JOINT ARCHITECTURAL BOARD/PLAN COMMISSION AGENDA
MONDAY, FEBRUARY 20, 2017
7:00 PM
BOARD ROOM
MUNICIPAL BUILDING, 210 COTTONWOOD AVE.

TO: Plan Commission
FROM: David E. Cox, Village Administrator
DATE: February 17, 2017
SUBJECT: Benchmark Secure Storage

Re: Village of Hartland
Benchmark Secured Storage-Plan Review Letter

PROPOSED SITE PLAN
FOR: LOT 2 CSM 9413
PART OF THE SW 1/4 OF SECTION 10, T7N, R18E
VILLAGE OF HARTLAND, WAUKESHA COUNTY, WI.

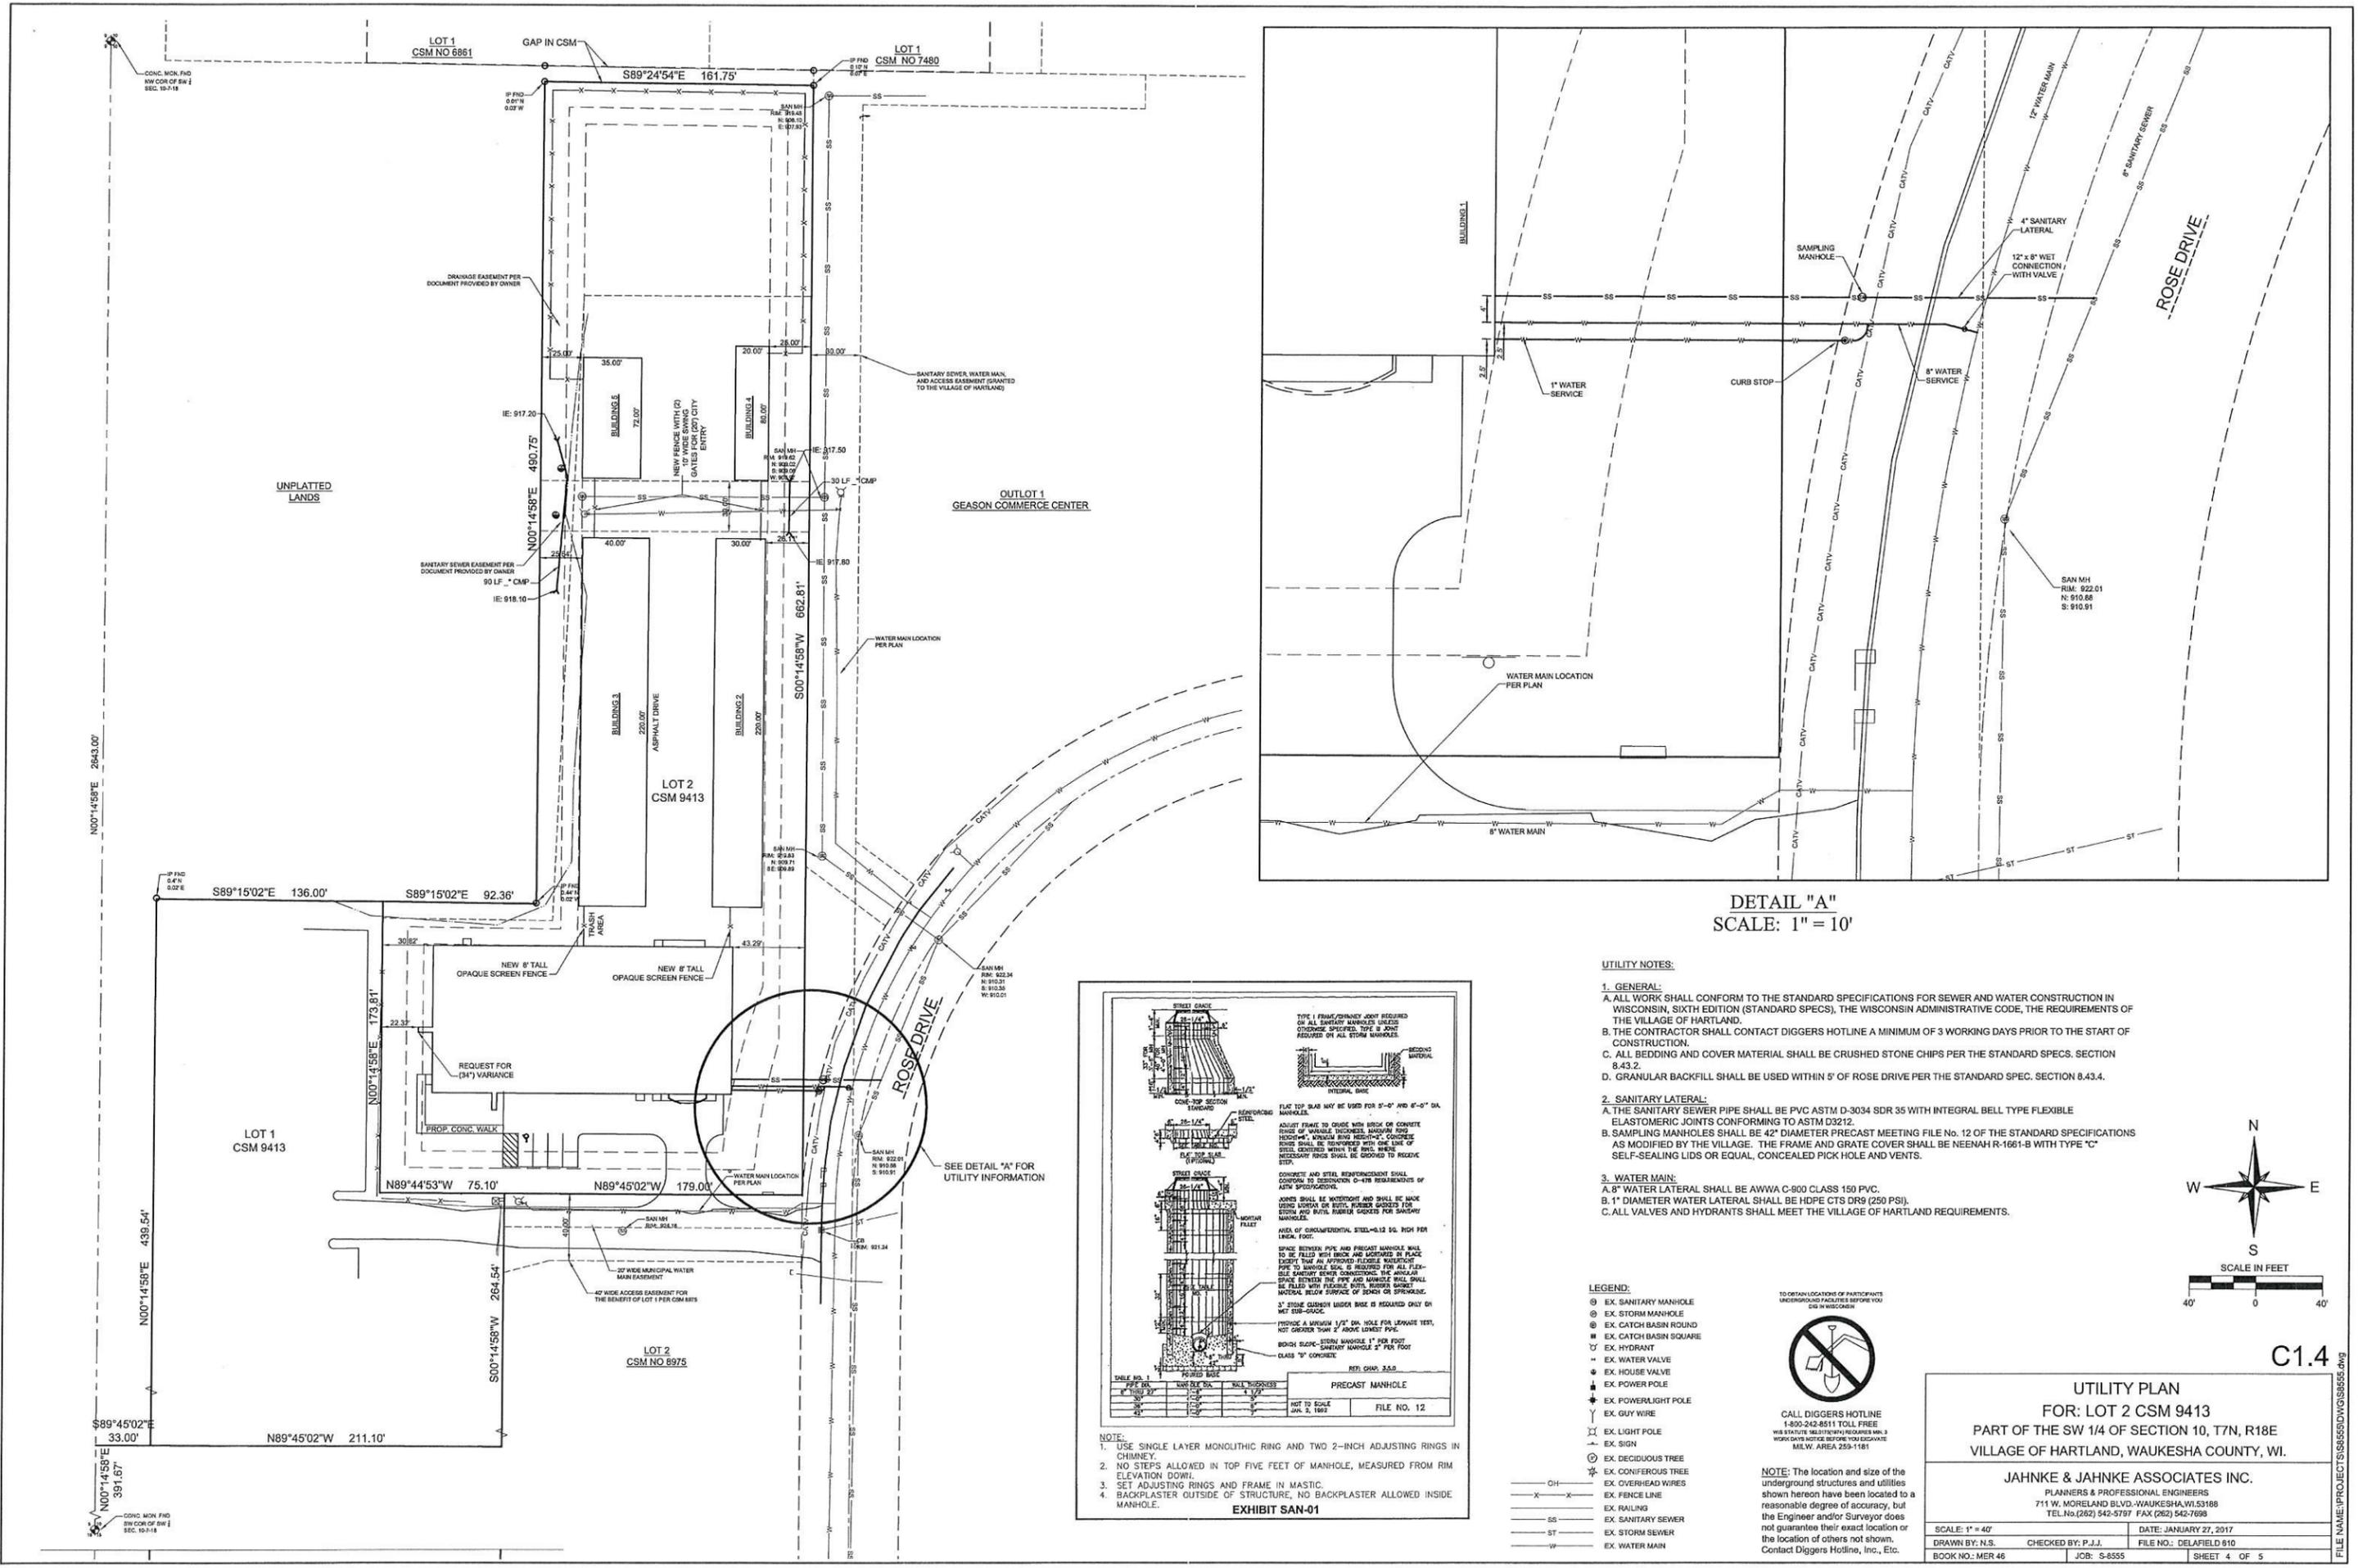
1. Architectural Site Plan and Engineering Site Plan shall be combined.
2. Obtain variance for building protrusion into westerly building setback.
3. Provide a minimum 12-foot wide asphalt drive for fire truck and DPW access centered within the Village's 30-foot sanitary sewer, water main and access easement and connect it to the asphalt drive in between the proposed buildings.

4. Provide (2) 15' wide swing gates for Village entry into the site. Please update note and change the term "City" to "Village".
5. Relocate the proposed west side fence and swing gate 8-foot to the west of the existing hydrant.

6. Provide a fence and swing gate detail.
7. Provide a No Parking sign in between both sets of buildings in the easements.
8. Show existing curb boxes and sanitary laterals for the adjacent northwest property

9. Provide a site coverage table listing the permeable and impervious totals for the site.
10. Include parking calculations.
11. Highlight the paved areas and show the paving limits along the north side of the site.

12. Provide a detectable warning field to ensure ADA Compliance for parking lots. .
13. Show details of construction.
14. Include a handicap sign and post.

15. Show dimension for parking stalls, driving aisle, sidewalk width and radii.
16. The dumpsters are shown within the secured area of the site. How will the garbage be pick up? Provide details for trash enclosure.

PROPOSED LANDSCAPE PLAN
FOR: LOT 2 CSM 9413
PART OF THE SW 1/4 OF SECTION 10, T7N, R18E
VILLAGE OF HARTLAND, WAUKESHA COUNTY, WI.

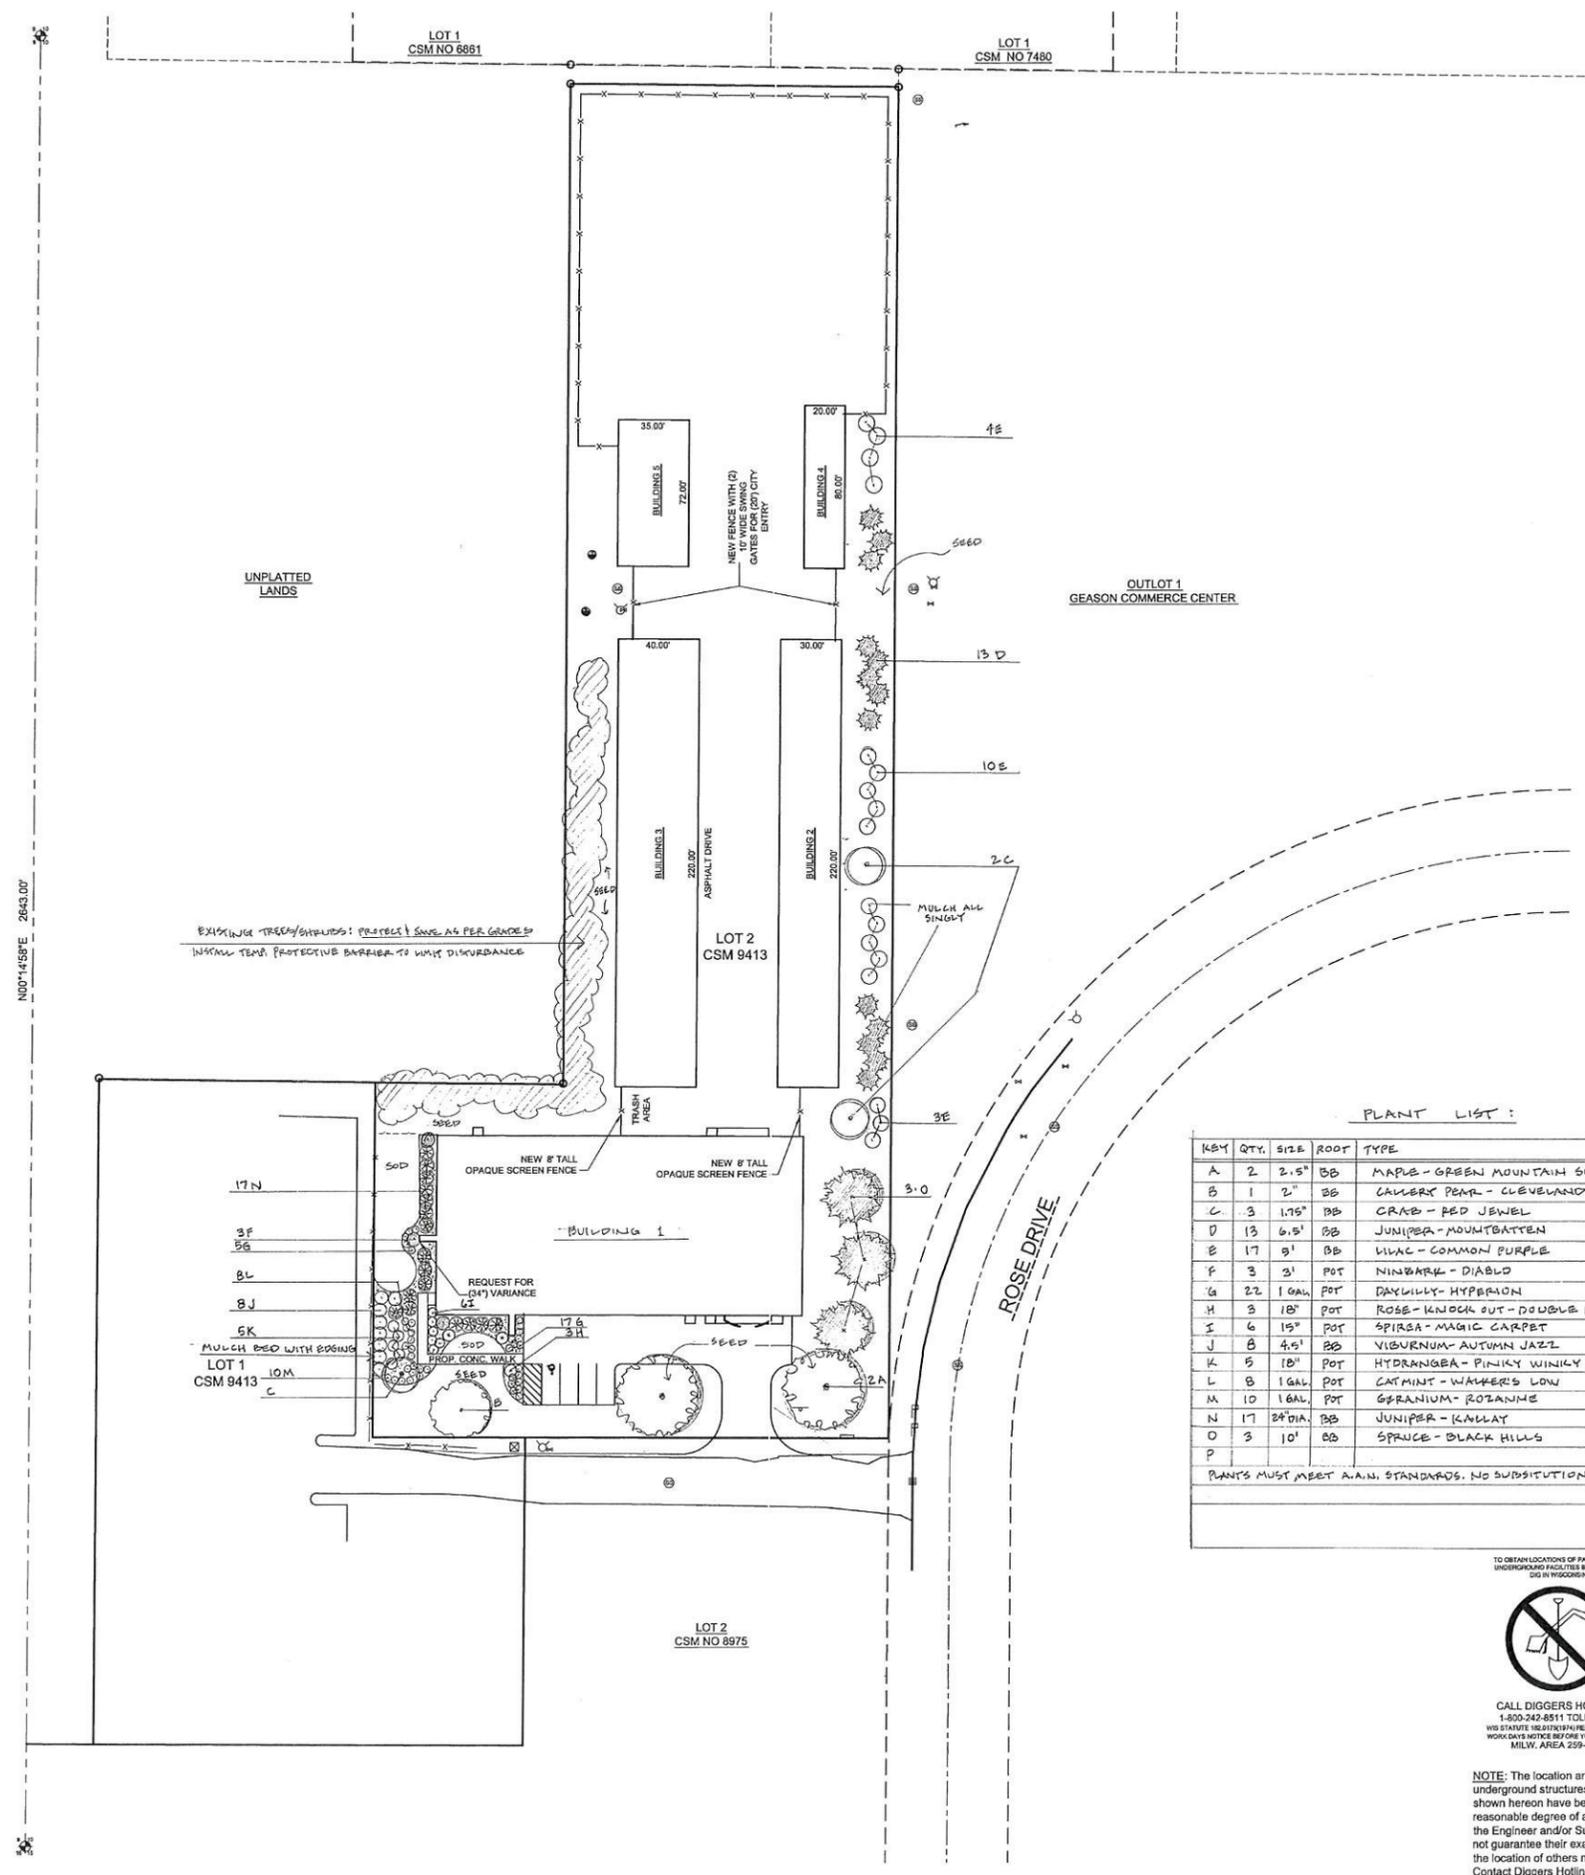
1. Show proposed swales and adjust landscaping to not conflict with drainage.
2. It appears that some of the existing trees/ shrubs along the west property line are Buckthorn. Any and/or all Buckthorn shrubbery shall be removed and replaced. Please verify and show additional plantings if necessary.
3. Provide screening to the proposed building #5.
4. Update fence note to provide for (2) 15’ wide swing gates for Village entry into the site. Please update note and change the term “City” to “Village”.

Architectural Site Plan

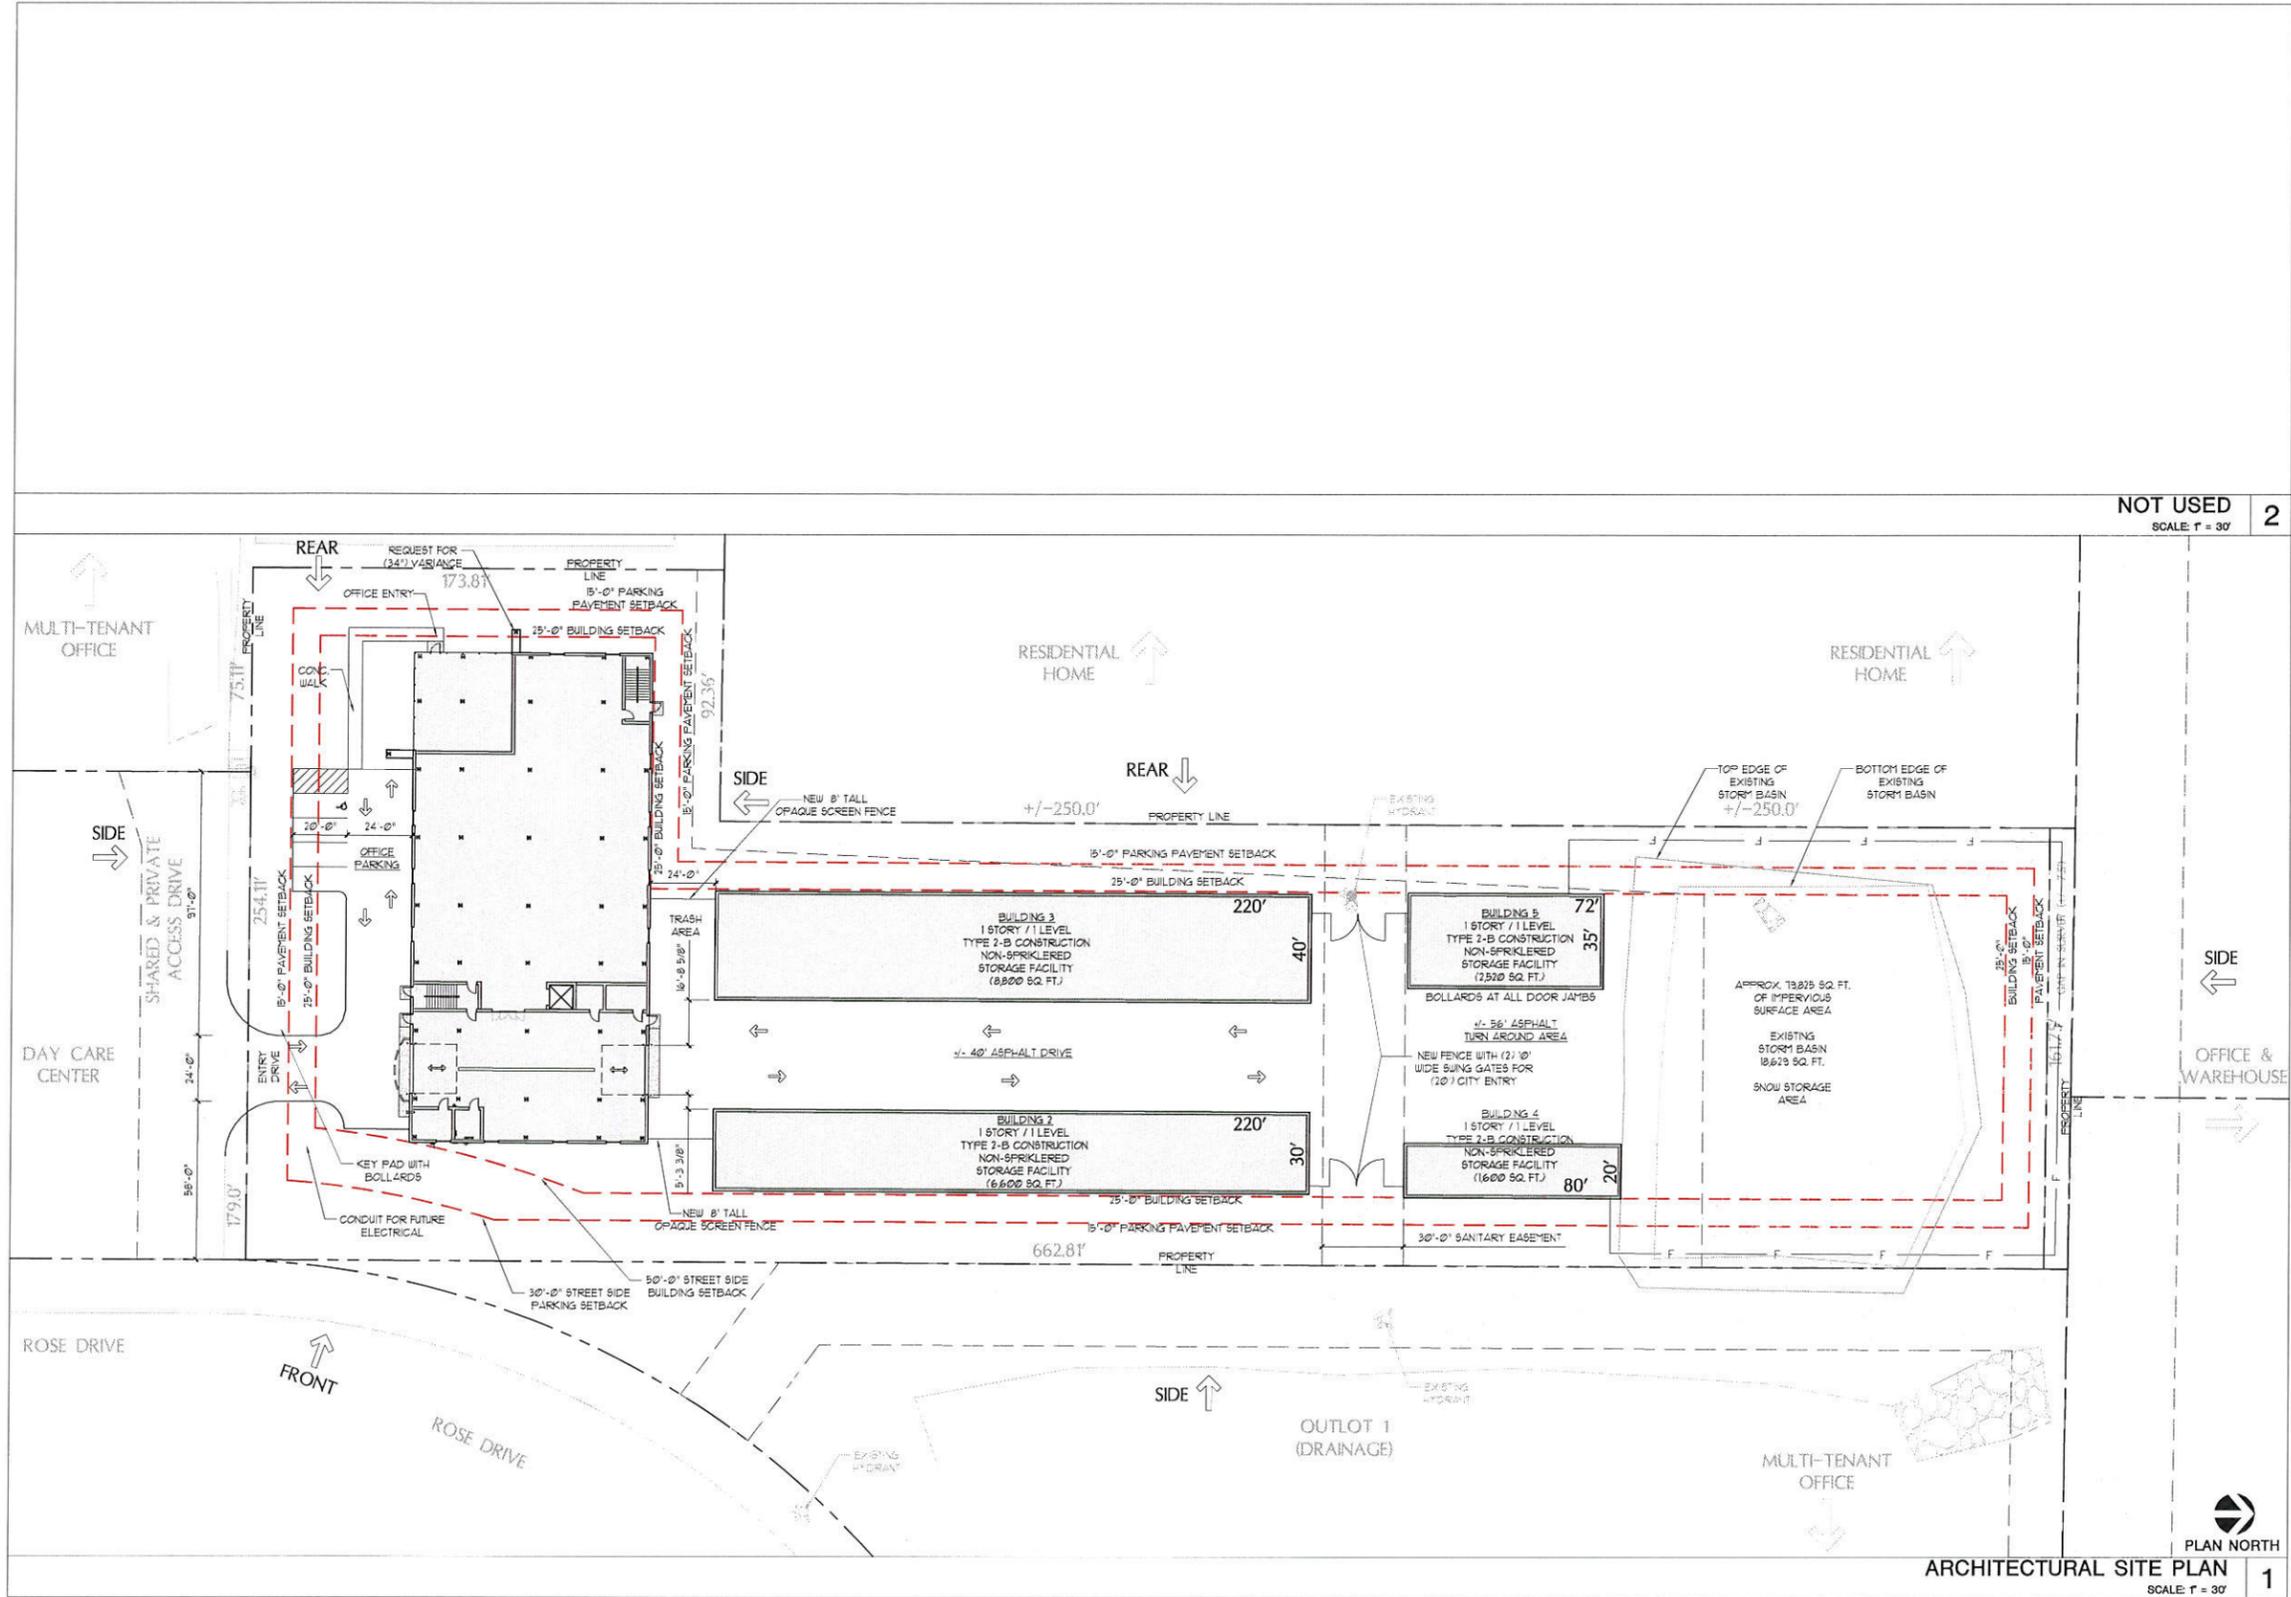
1. Architectural Site Plan and Engineering Site Plan shall be combined.
2. Show the doorway to building #3 and the trash receptacle to ensure there is no conflict between the two.
3. Provide standard traffic flow into site and a center island for the proposed key pad. Show the symbols and construction details for the key pad and bollards.
